REVISION TRANSMITTAL

This sheet transmits Revision 1 to SL560XL-76-04, which:

MANDATORY**SL560XL-76-04****TITLE**

ENGINE CONTROLS - THROTTLE QUADRANT RVDT LINKAGE INSPECTION

Figure 1. Throttle Quadrant RVDT Linkage Inspection (Sheet 1)

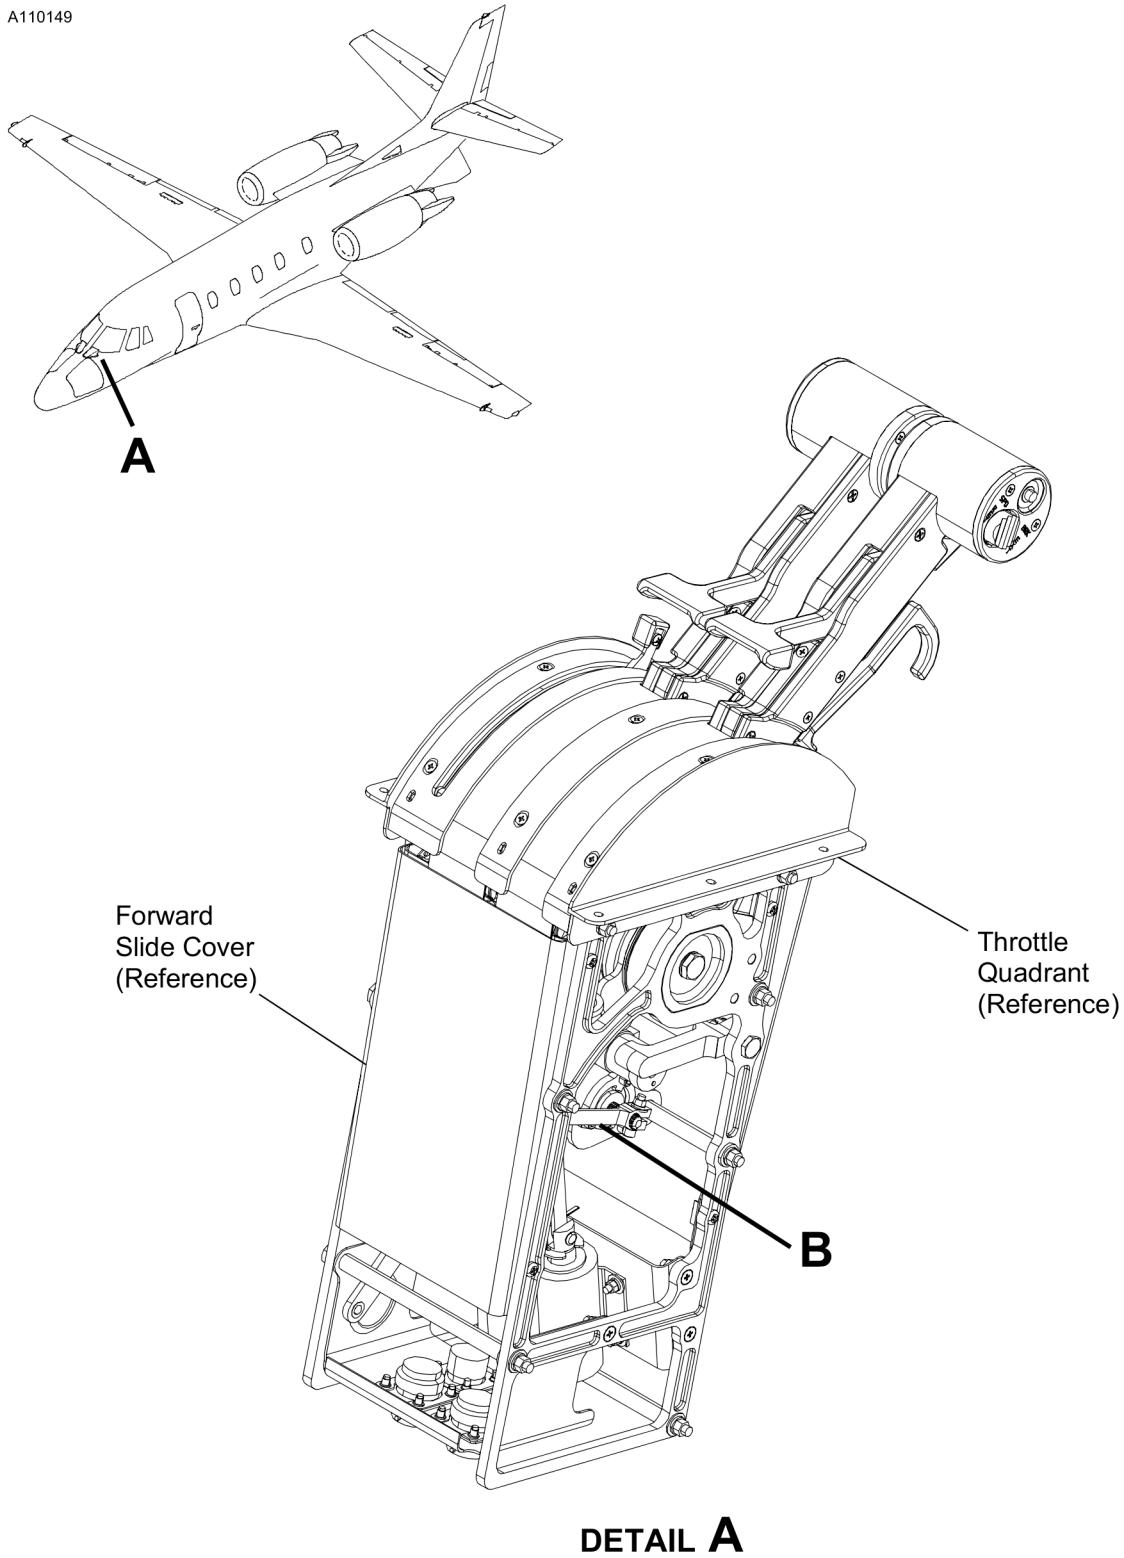
1. Prepare the airplane for maintenance.
 - A. Make sure that the airplane is electrically grounded.
 - B. Make sure that all switches are in the OFF/NORM position.
 - C. Disconnect electrical power from the airplane.
 - (1) Disconnect the airplane battery.
 - (2) Disconnect external electrical power.
 - D. Attach maintenance warning tags to the battery and external power receptacle that have "**DO NOT CONNECT ELECTRICAL POWER - MAINTENANCE IN PROGRESS**" written on them.
2. Remove the throttle quadrant. (Refer to the Model 560XL Maintenance Manual, Chapter 76, Throttle Quadrant Assembly - Removal/Installation (Airplanes -6001 and On).)
3. (Refer to Figure 1, Detail A, Detail B and View A-A.) Inspect the rivet in the left and right RVDT linkage that connects the Sensor Link and Sensor Drive Arm.

- A. Remove and keep the forward slide cover assembly to access the RVDT linkage.
- B. The minimum allowable diameter of the rivet butt is 0.210 inch and the minimum allowable height is 0.040 inch.
 - (1) If both rivets are installed correctly, go to Step 3.C.
 - (2) If either of the rivets is not installed correctly, do the steps that follow:
 - (a) For rivets that do not have the correct minimum diameter and are above the minimum height of 0.040 inch, do the steps that follow:

- 1 Use a C-squeeze to achieve the correct minimum diameter of 0.210 inch. Make sure the rivet butt height remains between 0.040 and 0.080 inch.
- 2 Inspect the rivet butt for cracks.
 - a If cracks are not found, go to Step 3.C.
 - b If cracks are found, go to Step 3.B.(2)(b)1.

- (b) For rivets that fail the minimum height or fail both minimum height and minimum diameter, do the steps that follow:
- 1 Mark the RVDT shaft and linkage to create an alignment mark with a fine tip marker.
 - 2 Remove the clamp from the applicable sensor link. Keep the attaching hardware except for the MS20142-06 Nut.
 - 3 Remove the applicable RVDT linkage from the throttle quadrant.
 - a Keep the attaching hardware except for the cotter pins and nuts.
 - b Remove and discard the current MS20470AD6-7.5 Rivet. (Refer to the Model 560XL Structural Repair Manual, Chapter 51, Fastener Installation and Removal.)
 - 4 Install a new MS20470AD6-7.5 Rivet through the bearing in the Sensor Drive Arm and Sensor Link.
 - a Make sure the butt of the rivet is 0.210 to 0.225 inch diameter and the height is 0.040 to 0.080 inch.
